CITY OF MORRO BAY PLANNING COMMISSION AGENDA

- B-1** **Case No.:** CDP 21-014/VAR21-001/PAR22-02
Site Location: 3202 Beachcomber Drive, Morro Bay, CA
Proposal: Application for a Coastal Development Permit, Variance Request and Parcel Map for property located at 3202 Beachcomber Drive. The project consists of a reallocation of the three existing non-conforming parcels into two conforming sized parcels. This project is located on the southern most parcel. The land action requires the demo of the existing single-family home since it crosses over the proposed property line. Following the land action and demo, the project proposes new construction of a 2567 sf home with a 963 sf roof deck and a 2412 sf subterranean garage. The applicant has requested a variance to allow a 12 inch windscreen on top of the required deck railing that exceeds the height limit of 14 feet. The zoning is R-1/S.2A (RS-B new zoning designation) and the site is in the Coastal Appeals Jurisdiction.

- B-2** **Case No.:** CDP21-024 / VAR21-002
Site Location: 3230 Beachcomber Drive, Morro Bay, CA
Proposal: Application for a Coastal Development Permit and Variance Request for new construction of a 1684 sf home with

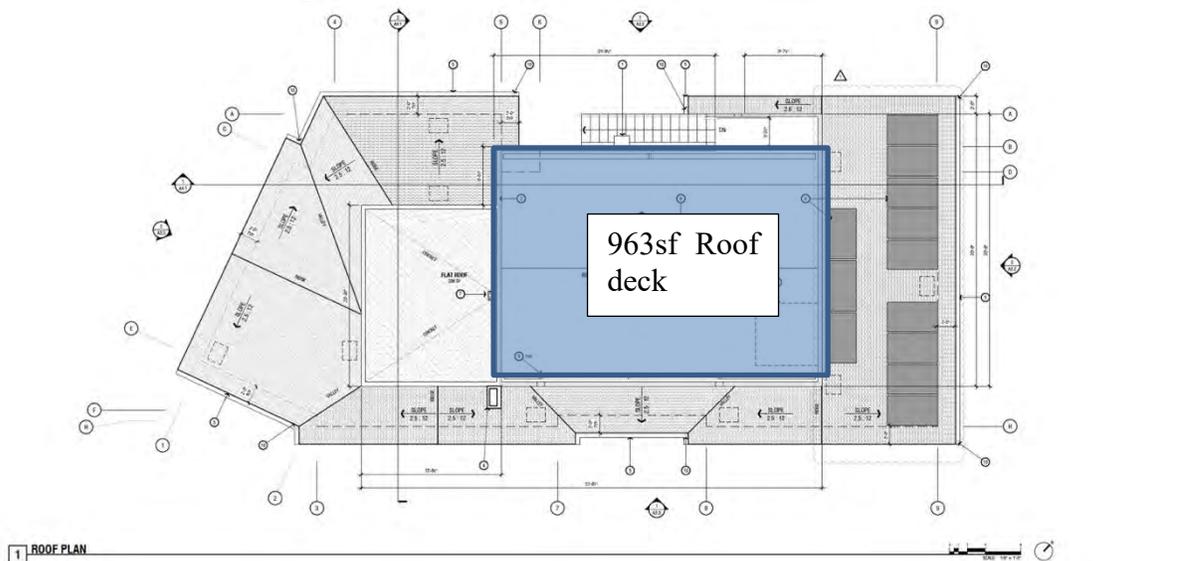
Roof Deck: The image above is a building section to show the height of the railing/windscreen and the elevation of the floor of the roof deck (slightly raised in the center for drainage). The parapet walls shown on each side of the building section above are about 4 feet in height but drop down one foot on the north and south sides of the roof deck, replaced by clear windscreen material. Below is a floor plan for the roof level. Solar is shown on the right side of the roof.

Building Section showing roof deck Exhibit E

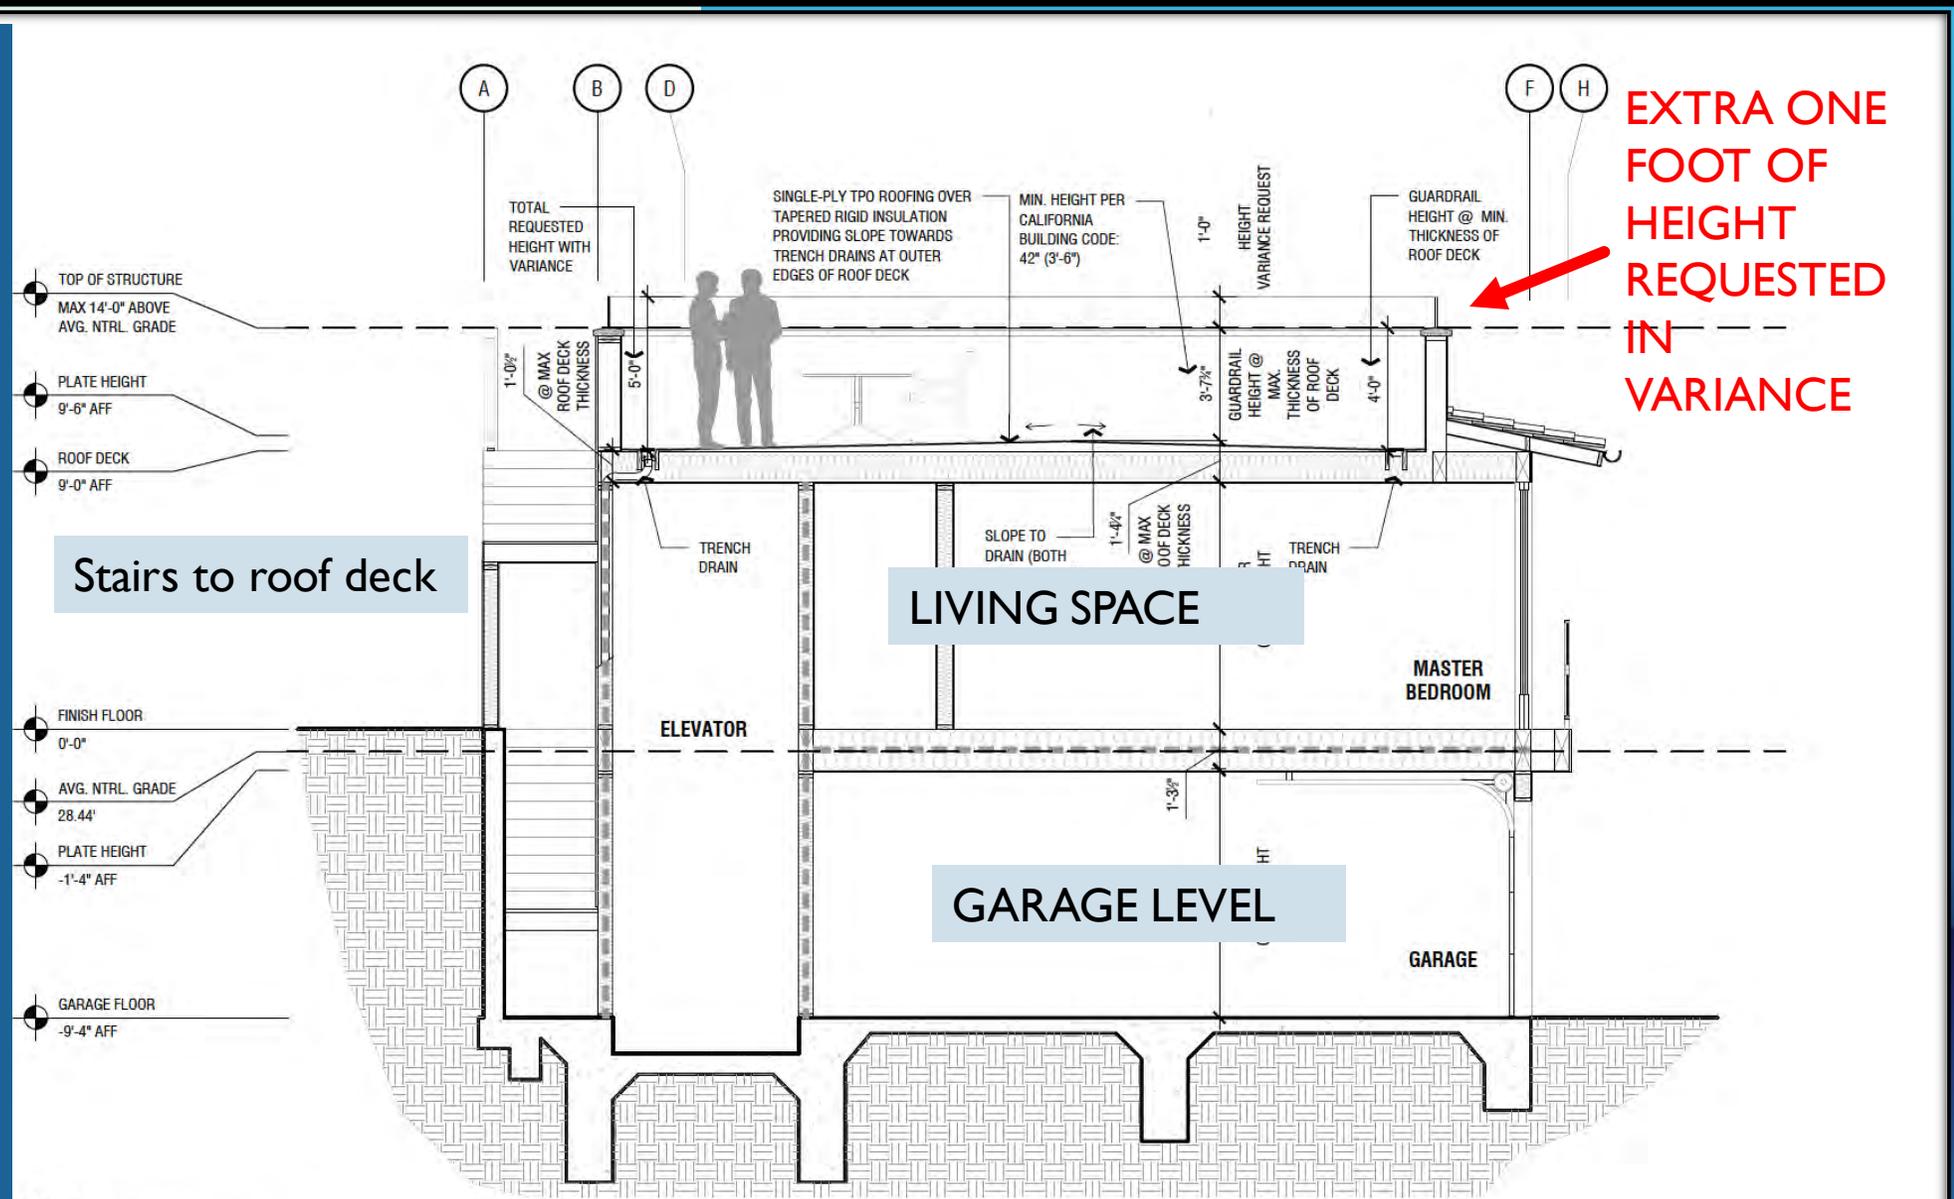
- Railing without additional 12 inches in height for windscreen meets code (42")
- Parapet walls on west and east are at full rail height
- Parapet walls on North and South are lower and don't screen view of roof deck

Finding I: The Request does not constitute a special privilege not afforded to other homes in the area.

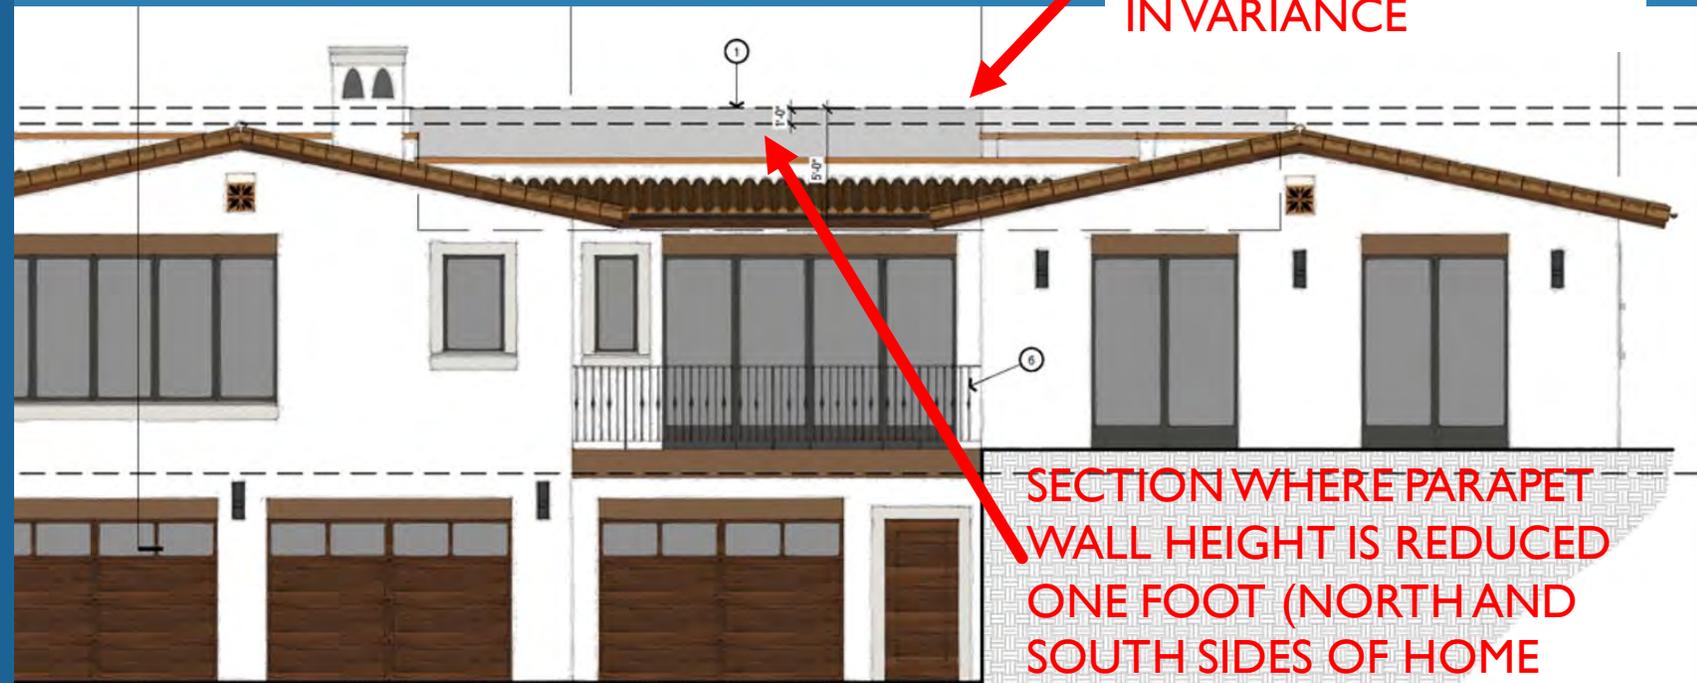
Staff Response: Other homes in the area have complied with the height standards. There is no conditions that staff is aware of that would allow a height exception for a windscreen that would not be considered a grant of special privilege

Finding 2: There are special circumstances with the property that deprive this property of privileges enjoyed by other properties in the vicinity.

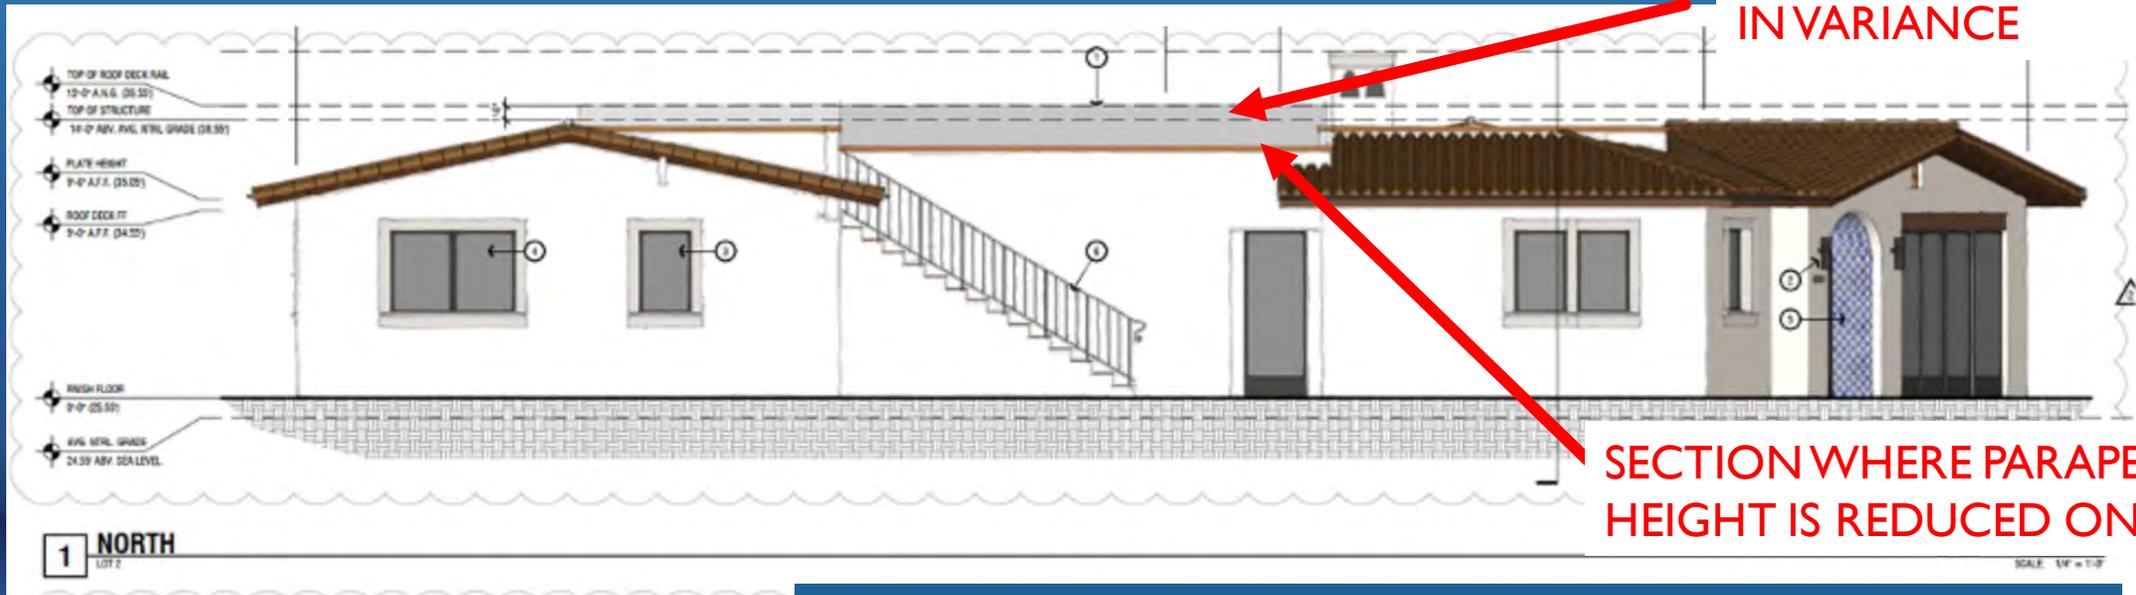
Staff Response: There are no special circumstances existing at the site to justify the requested variance and as such the findings cannot be made and the variance should not be granted.

Finding 3: That the request is consistent with the General Plan and Local Coastal Plan related to protection of scenic resources and meets the Development Standards.

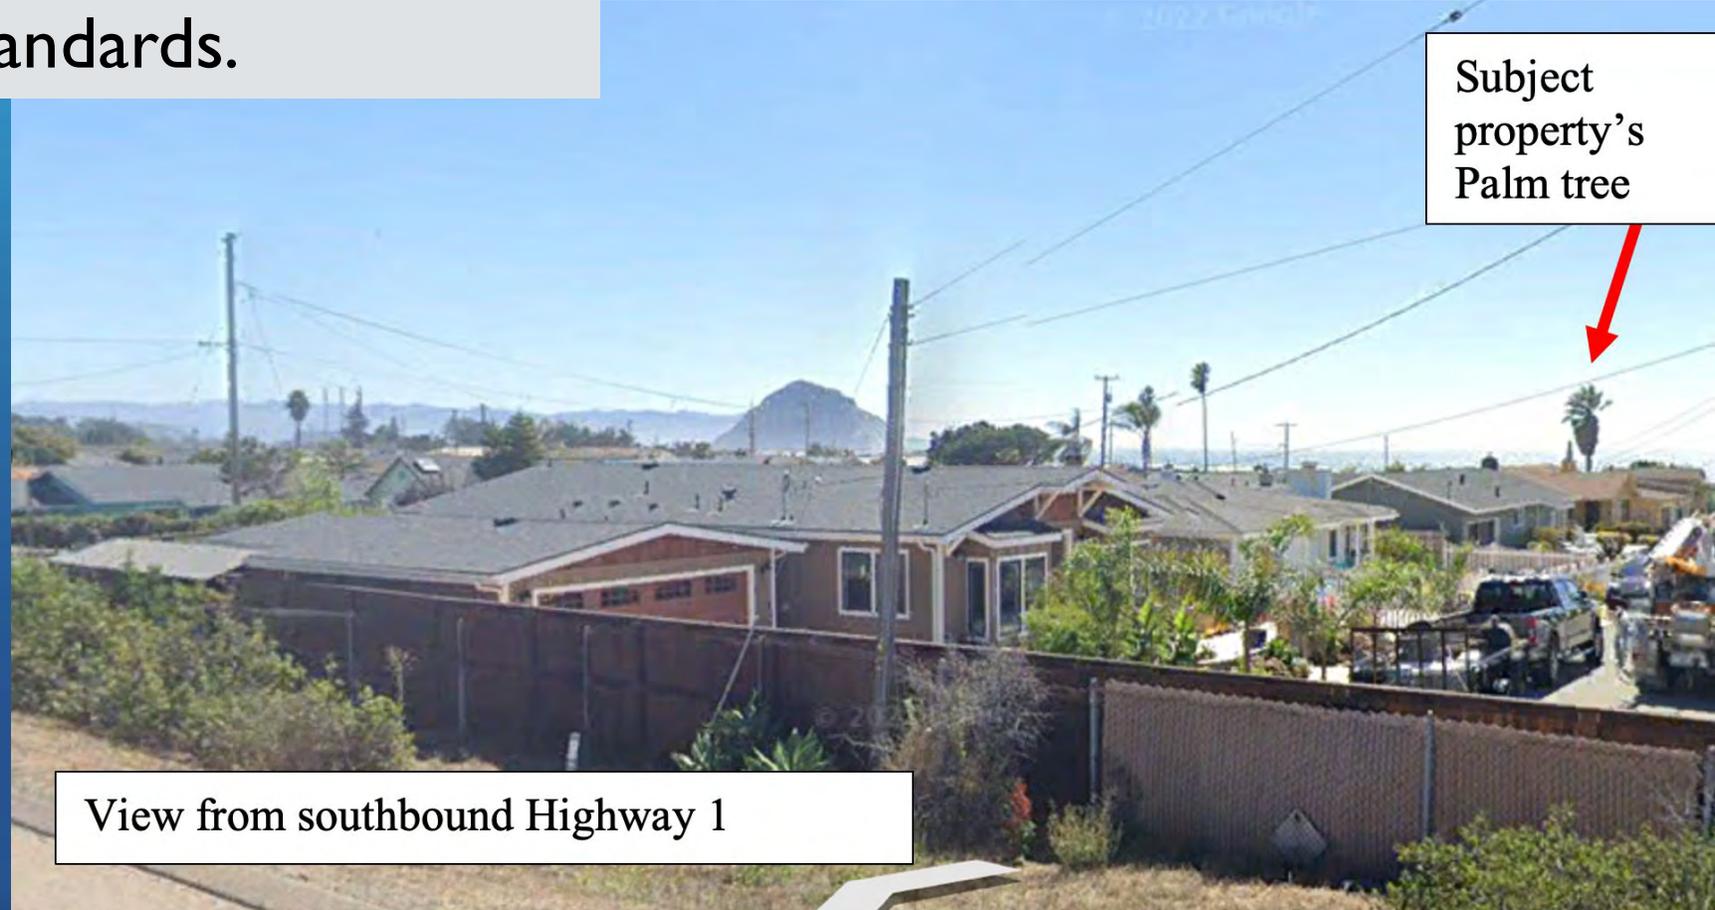
*Staff Response:
Although the additional height does not interfere with public views, the variance request does not comply with the development standards (height requirement) and therefore, there are no special circumstances that warrant granting this request.*

Building section – to show roof deck – view from Beachcomber

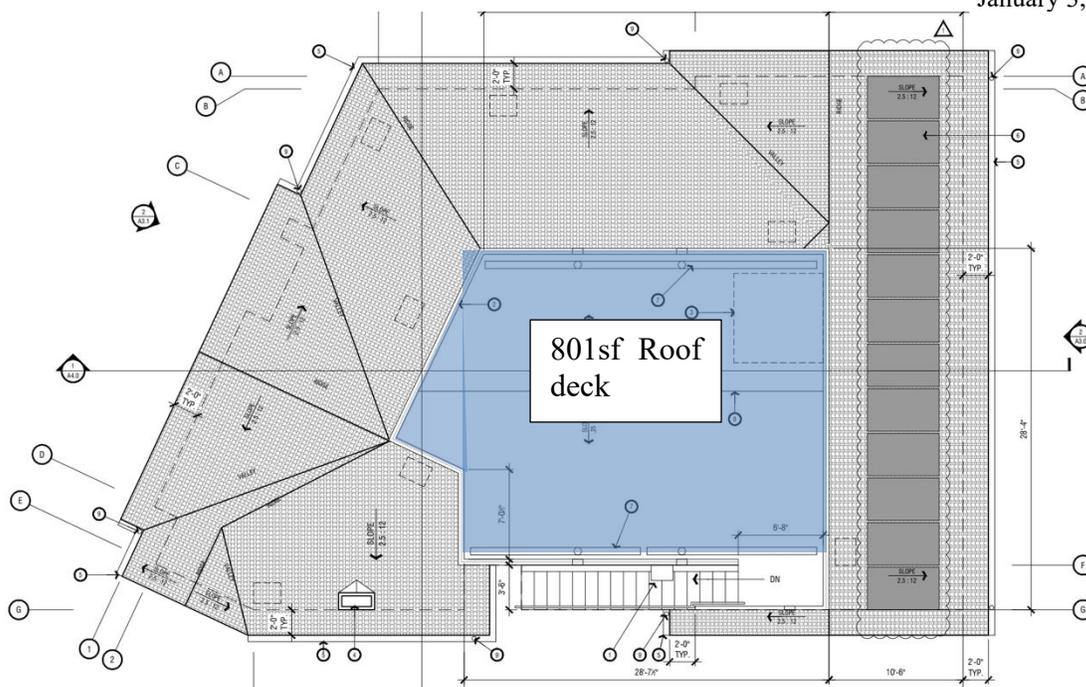
Roof Deck: The image below is a building section to show the height of the railing/windscreen and the elevation of the floor of the roof deck (slightly raised in the center for drainage). The parapet walls are less than the required safety rail height (42") on all sides providing for larger areas with clear windscreen material. Below is a floor plan for the roof level. Solar is shown on the right side of the roof. The Resolution (Exhibit A) includes a planning condition of approval that requires the parapet walls to be increased in height to 42 inches from the finish floor of the roof deck to provide better screening from pedestrian view to meet the residential design guidelines (i.e., not introducing new materials not otherwise included in the exterior finishes of the home). The parapet walls in no case shall exceed the 14-foot height limitation in the zoning standards.

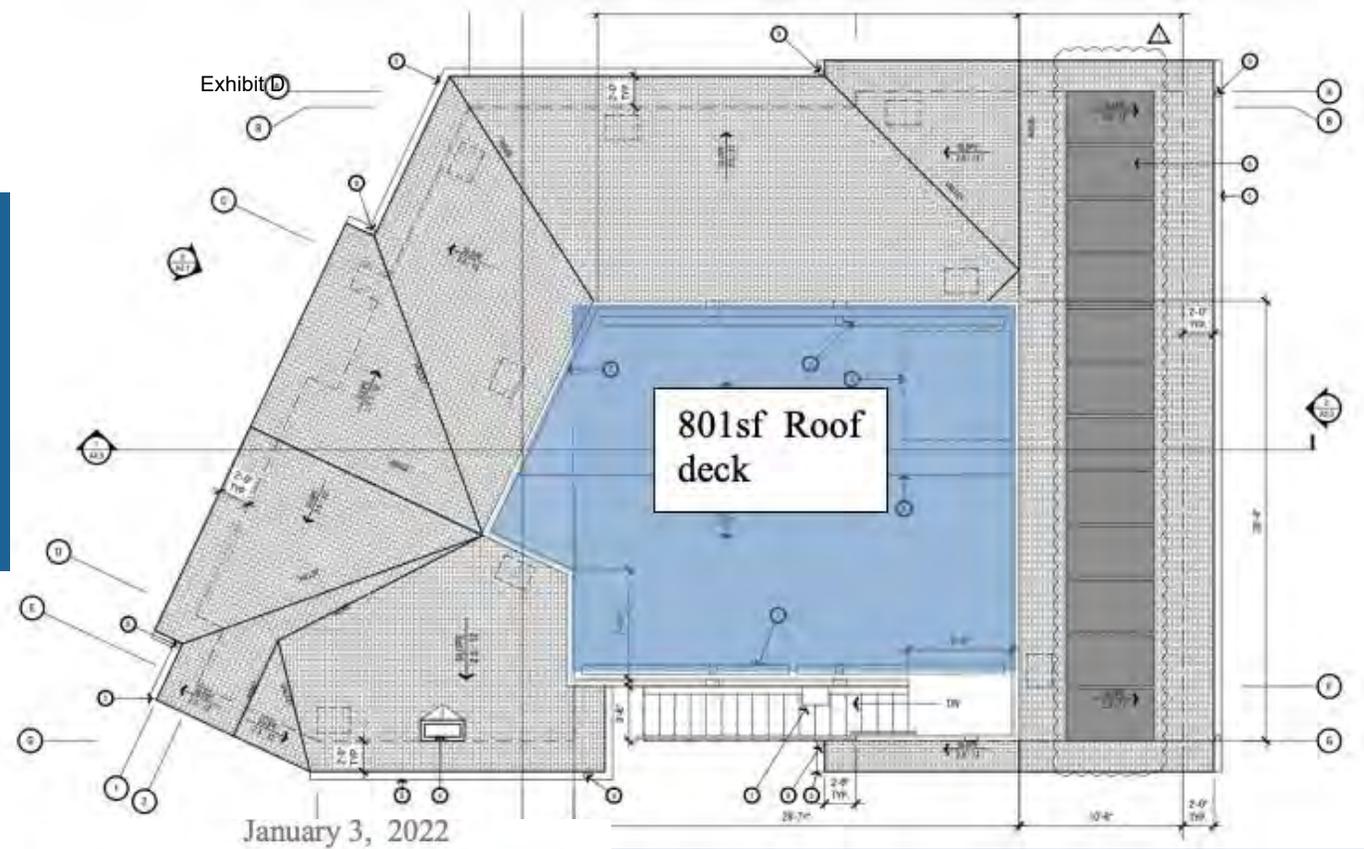
Note: Parapet walls are all too low and do not screen as much view of roof deck

Building Section showing roof deck Exhibit D

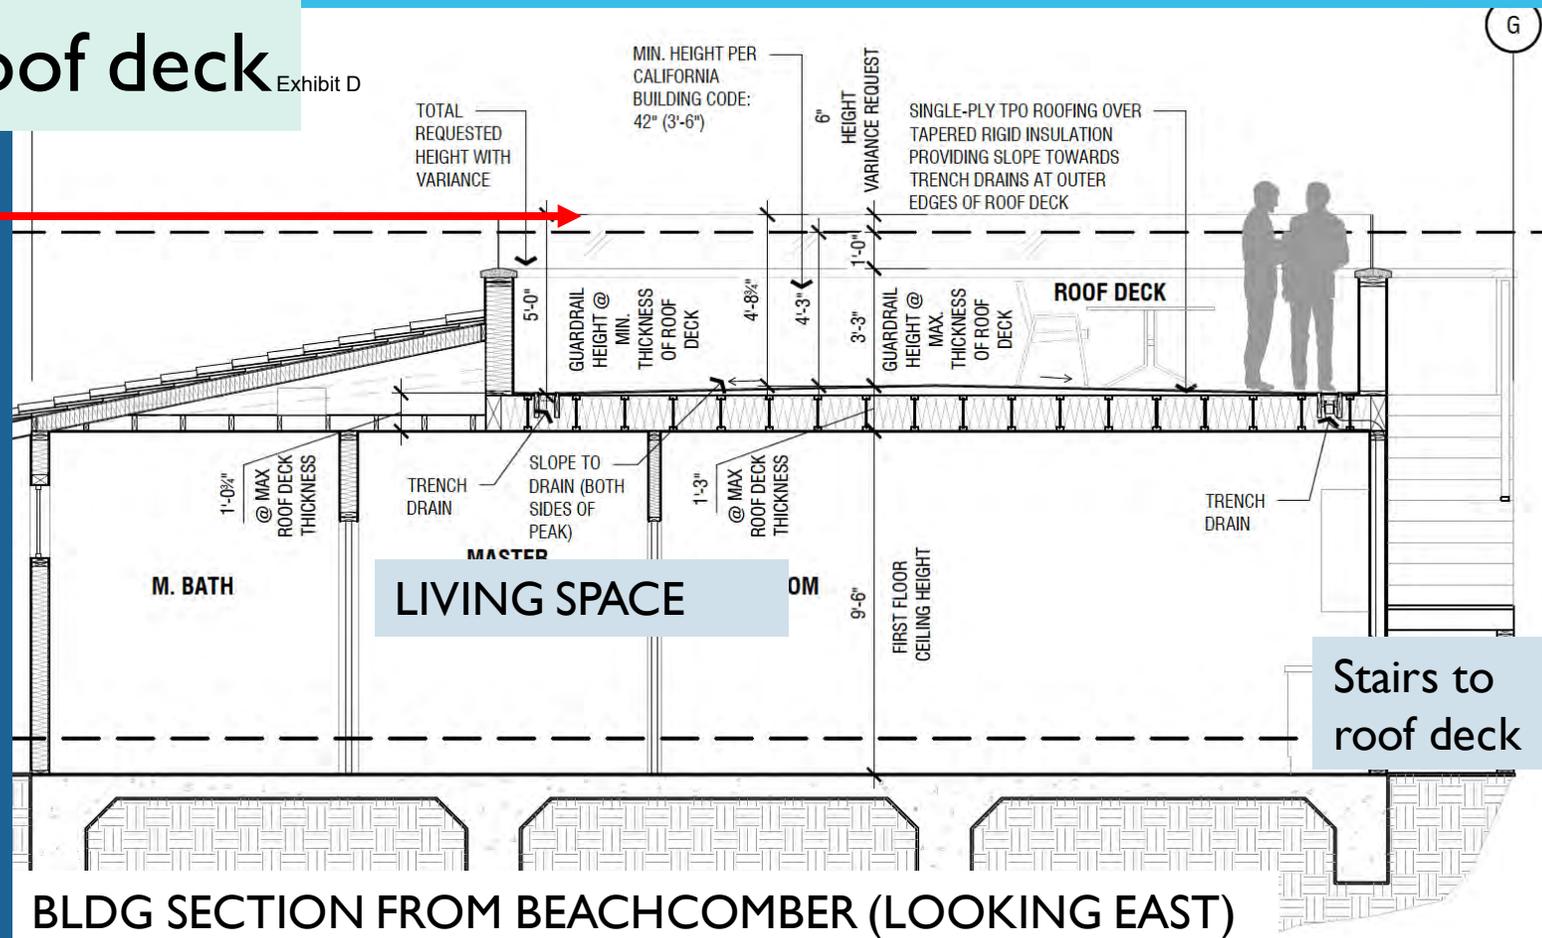
- Windscreen is 6 ½ inches over height limit in the zone (shows 5 ft height railing (18 inches higher than safety railing requirement))
- Parapet walls on all sides are too low and have been replaced with windscreen material which does not screen view of roof deck
